Subject: De Minimis Waiver No. 26-005 – An application for a new pool and spa to be used for fire suppression purposes for a parcel affected by the Woolsey Fire

Location: 32826 Pacific Coast Highway, within the appealable coastal zone
APN: 4473-016-015
Owner: Bottlebrush LLC

De Minimis Waiver

POOL PLAN AND DETAILS

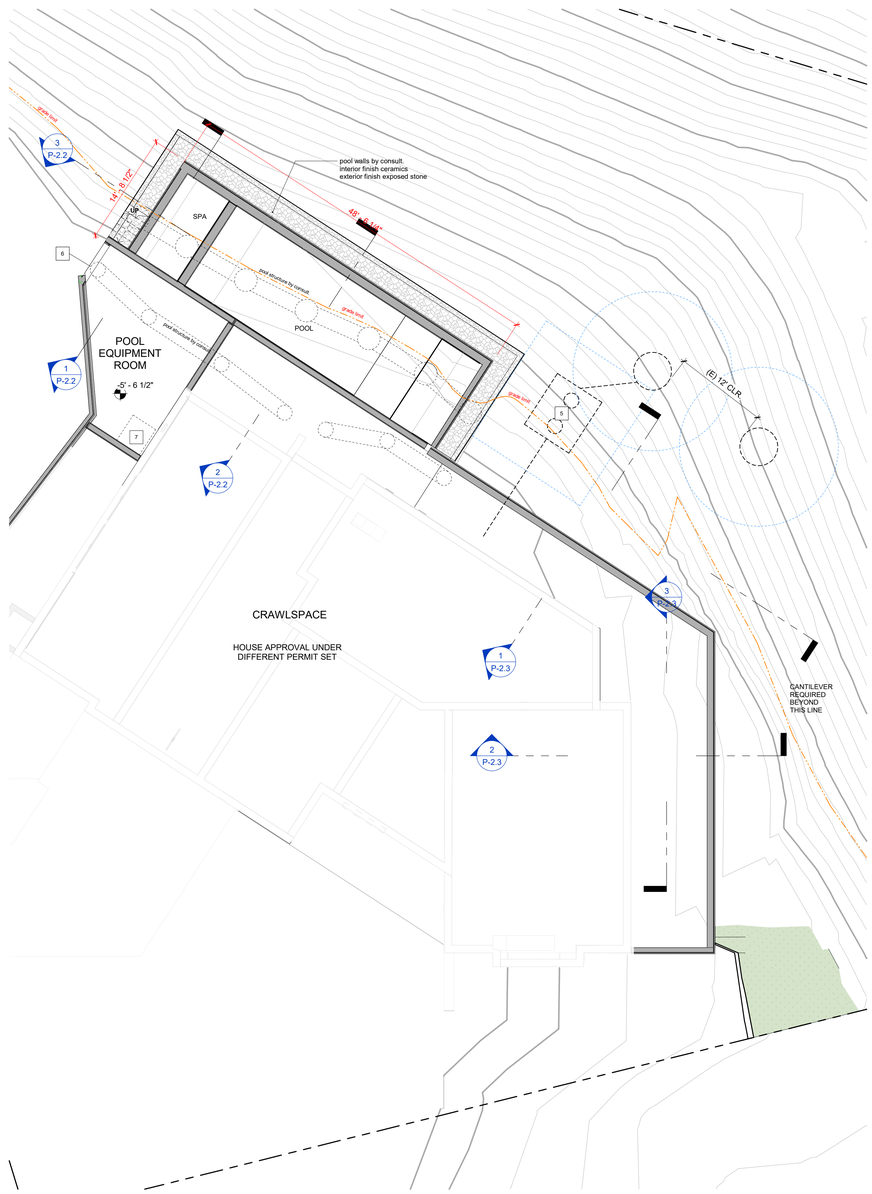
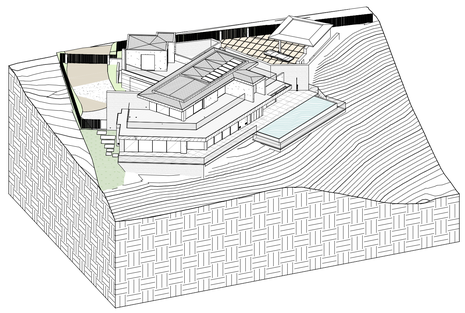
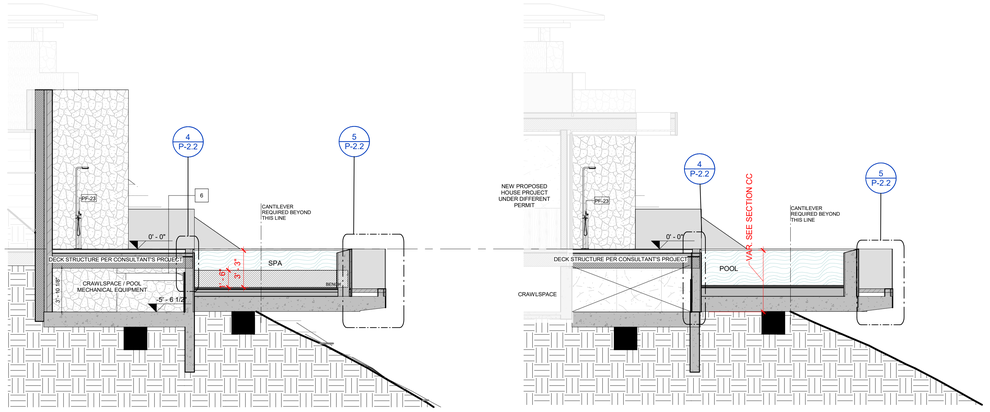
22. Sheet P-2.1 of the Studio Arthur Casas plans dated 6-9-2025 depict a proposed outdoor shower. A note shall be incorporated into the project plans stating: “The proposed outdoor shower shall not drain to the existing onsite wastewater treatment system (OWTS).”

4) **Proposed Pool Shower Note:** Sheet P-2.1 of the Studio Arthur Casas plans dated 6-9-2025 depict a proposed outdoor shower. A note shall be incorporated into the project plans stating: "*The proposed outdoor shower shall not drain to the existing onsite wastewater treatment system (OWTS).*"
